Shenzhen qiuyu Electronic Co., Ltd

CLASS II PERMISSIVE CHANGE REQUEST

RE: Class II Permissive Change Request
FCC ID: 2AL64-RE667-PRO
IC ID: 24702-RE667PRO

2. Power boards re-designed.
Old Power boards:

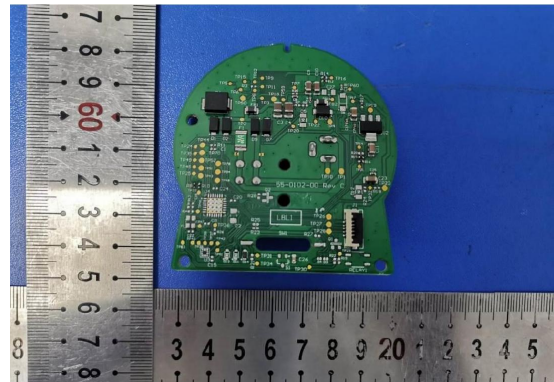
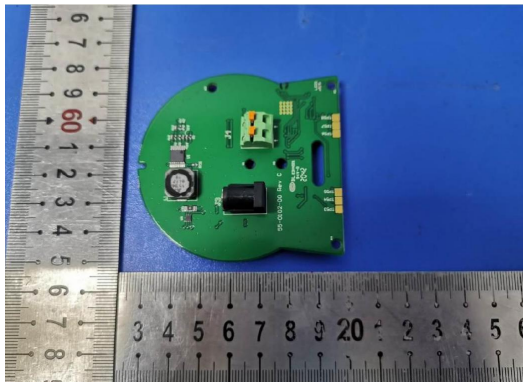
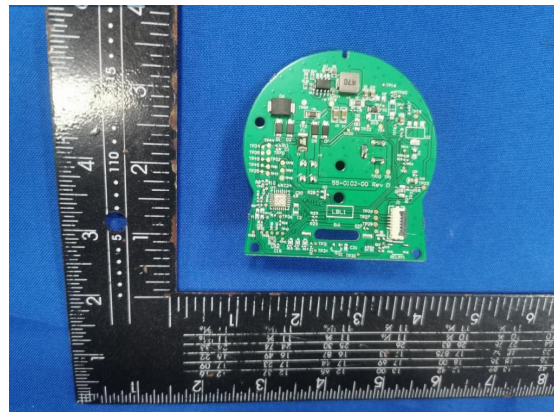
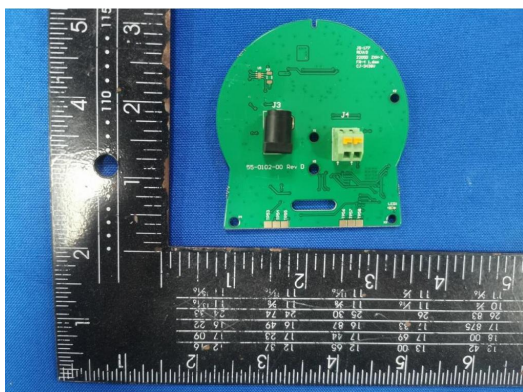
New Power boards:

Based on above that the AC power line conducted emissions and emissions in restricted frequency bands including band edge are re-assessed.
